## INFORMATION BULLETIN

No. M 6-III/42  
M 137 A/9  
M 137 AZ/3  
M 337/72  
M 337 A/3

**CONCERS:** Reconstruction of the distributor arm and cam of the magneto LUN 2221.13 type 52-9276.57

PŮVODNÍ PROVEDENÍ  
 БЫЛО  
 PRIMARY DESIGN

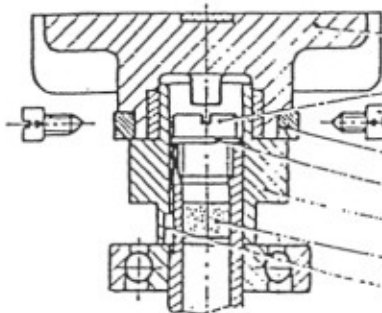
**MEASURES:** A structural change in the attachment of the distributor arm on the cam was conducted to increase the service life and reliability of the distributor arm. Magnetos produced since the second half of 1975 have a new distributor arm and cam. Former types are no more in production and can be replaced by new types.

If it is necessary to replace the former type of the distributor arm, the former type of cam will have to be replaced by a new type as well due to structural differences.

1 piece distributor arm Drawing No. 402-8416.21  
1 piece cam No. 302-3890.62

1 piece distributor arm Drawing No. 402-8437.43  
1 piece cam No. 302-3890.77  
1 piece ring No. 402-6014.75  
2 pieces bolt No. 402-0522.07  
125+3 mm locking wire 0.8 mm ČSN 42 6410.5
